### **HENDERSON COUNTY TECHNICAL REVIEW COMMITTEE**

**SUBJECT:** Revised Combined Master and Development Plan for Hickory Nut Forest  
Major Subdivision (2012-M02)

## Henderson County Planning Department Staff Report

### Revised Combined Master and Development Plan Hickory Nut Forest Subdivision (2012-M02)

**Map A: CCP Future Land Use Map**

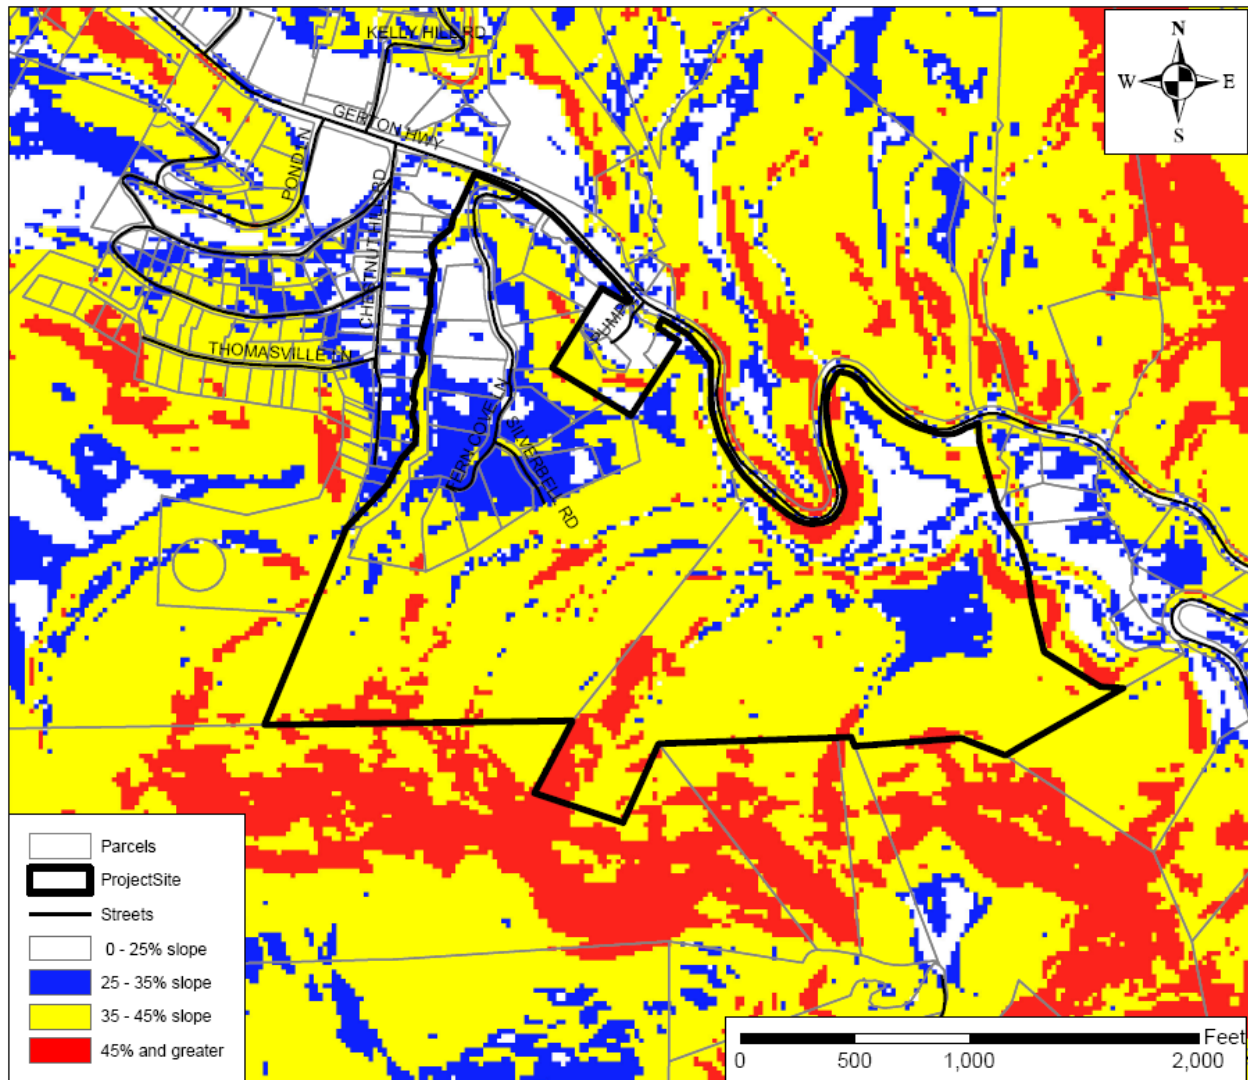
1. **Henderson County 2020 Comprehensive Plan (CCP).** The Future Land Use Map of the CCP shows the project site as being located within each of the following areas: Conservation Area and Rural Agricultural Area (USA) (See Map A: CCP Future Land Use Map).

(a) **Conservation Area.** The conservation area designation is applied to a majority of the project site, largely due to slope and a protected mountain ridge (See Map A: CCP Future Land Use Map, Map B: Slopes Map, and Map C: Protected Ridges). The overwhelming majority of slopes within the project site appear to be in excess of 25 percent, with portions having slopes in excess of 45 & 60 percent. According to the plan, a majority of the areas designated as above 35 percent slope are areas within the project site located in designated common area/open space. The CCP states that conservation

lands “are intended to remain largely in their natural state, with only limited development,” and further that “such areas should be targeted for protection through regulations and incentives” (2020 CCP, Pg. 134). (See Attached, Master Plan & Development Plan).

**Map D: Official Zoning Map**

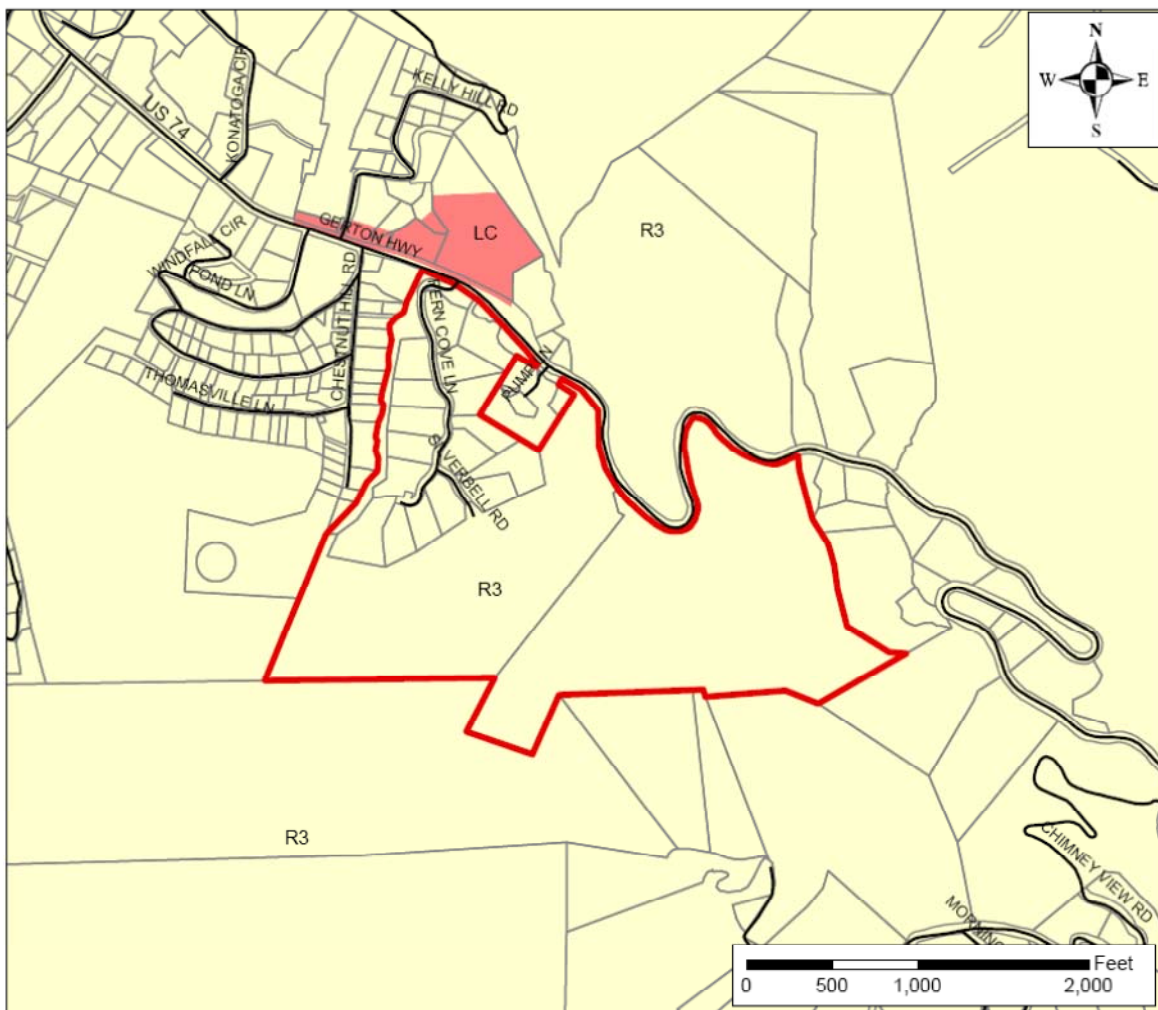
2. **Chapter 200A, Henderson County Land Development Code (LDC).** According to Chapter 200A, Henderson County Land Development Code (LDC) and its Official Zoning Map adopted September 19, 2007 (as amended), the proposed project site is located within the Residential Three (R3) (See Map D:Official Zoning Map). The R3 district allows for single-family residential development.

Combined, the original tracts 1-19 total 114.5 acres. R3 allows for a standard residential density of .66 units per acre. Because 10% or more of the project site is not within 60% slope or more the steep slope density reductions would not apply. Therefore, the LDC allows for a maximum of 75 units on the project site. The Master Plan proposal of 25 lots would fall within the density permitted by the LDC.

# HICKORY NUT FOREST SUBDIVISION

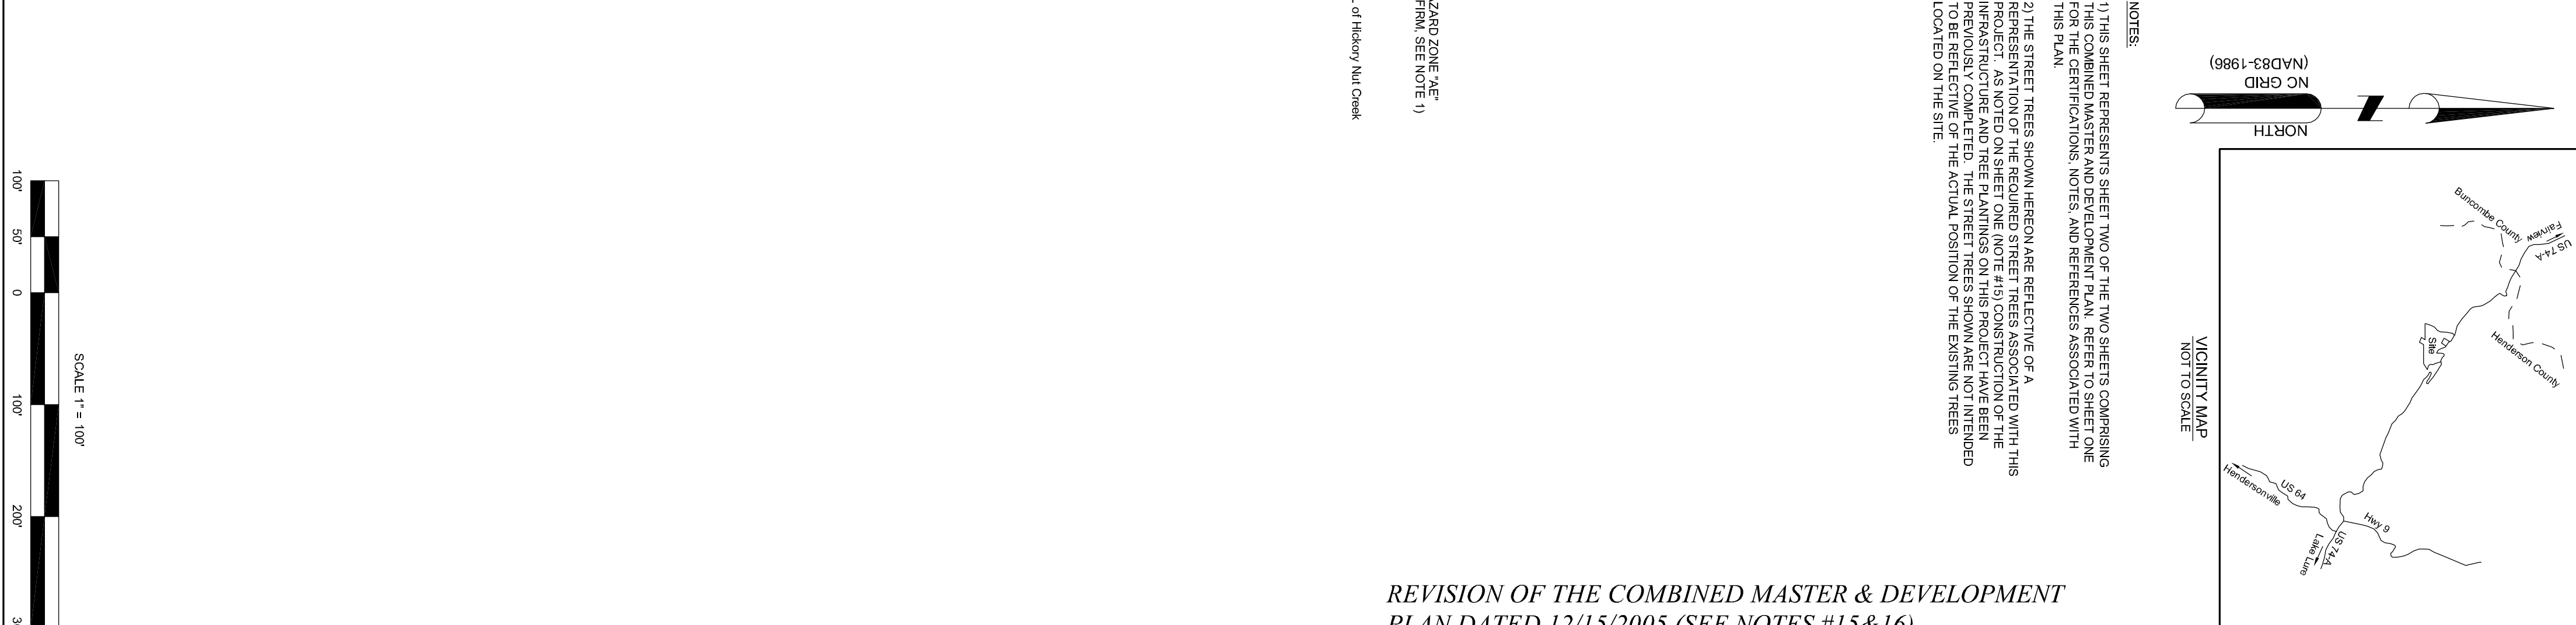
2. **Private Roads.** Fern Cove Lane and Silverbell Road are both existing local roads: The applicant is proposing two (2) private driveway easements, shown to access new lots #3 and #23. The existing private roads appear to and must, as a condition of approval, meet the standards of LDC §200A-104. The final plat(s) must contain a note stating: *The private roads indicated on this final plat may not meet the requirements of the North Carolina Department of Transportation for acceptance into the state road system.* Planning Staff proposes the following conditions to ensure the private roads meet the standards of the Land Development Code:

- c. **Dead Ends, Cul-de-sacs and Turnarounds.** The Applicant proposes one (1) branch turnarounds located at the end of local road, Fern Cove Lane. All turnarounds must meet of the LDC §200A-105 C(8). The reviewing agency may require additional turnarounds at intermediate locations along dead end roads with a centerline length of greater than 2,500 feet (LDC §200A-105D).

3. **Open Space: Conservation Subdivision Standards.** Of the approximate 62.1 acres within the project site, 30.6% is proposed as conservation area. This amount, meets the 25% conservation area requirement for the Conservation Subdivision Option in the Land Development Code.

7. **Road Name Approval.** Proposed road names for a private and/or public road shall be preapproved by Henderson County in accordance with Chapter 142 of the Henderson County Code, Property Addressing (LDC §200A-98). The applicant lists the proposed road names for most road segments. The names of the shared drives should be confirmed with the development plan approval.
